The old CPU09GPP card seems to use the wrong bus signals.

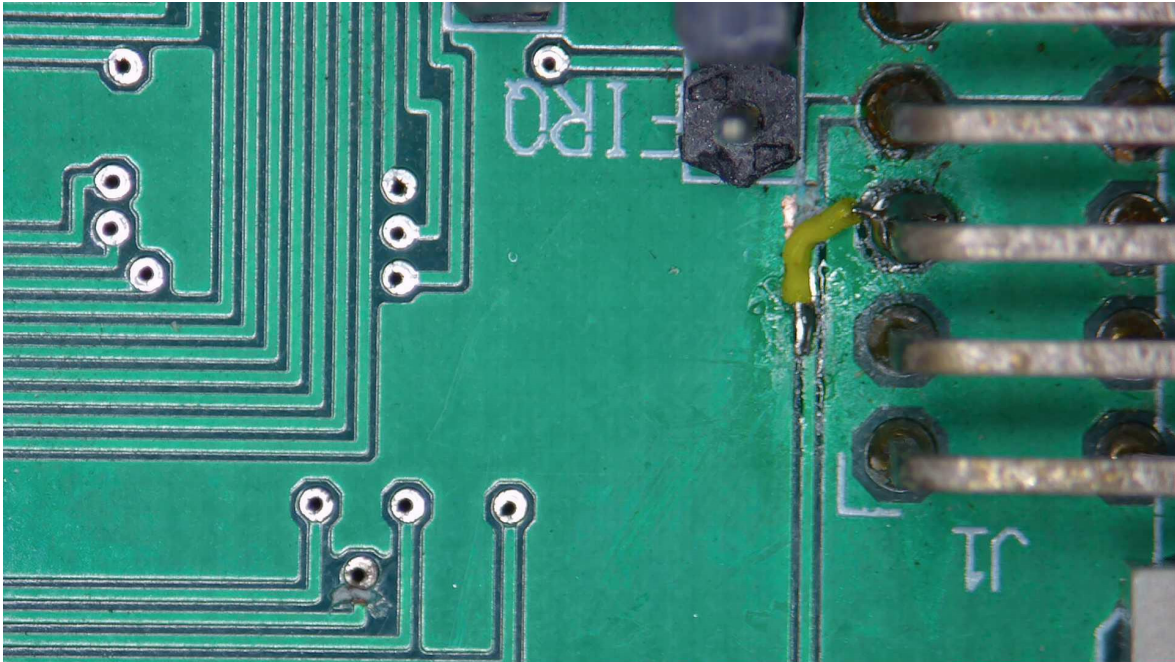
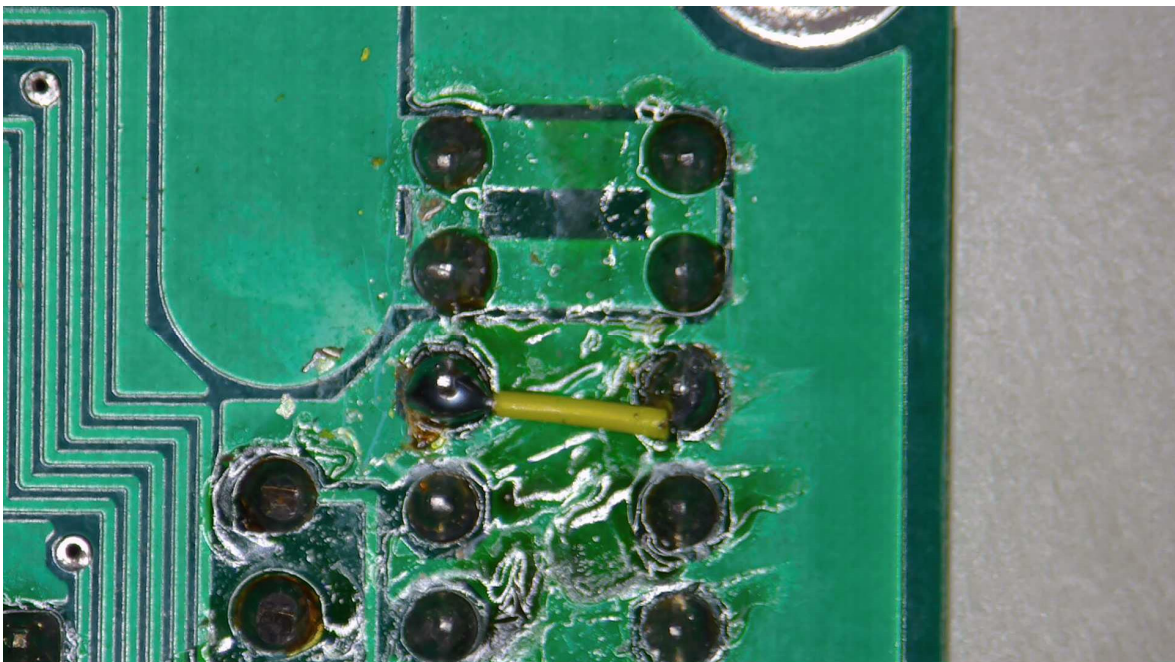
The SIG30 is not connected with AC64 pin A30 and C30 but on A29 and C29!

Just cut the trace on the part site and connect it to C30 add the bottom connect C30 to A30.

New patch

^ Old patch

Connect C30 to A30.
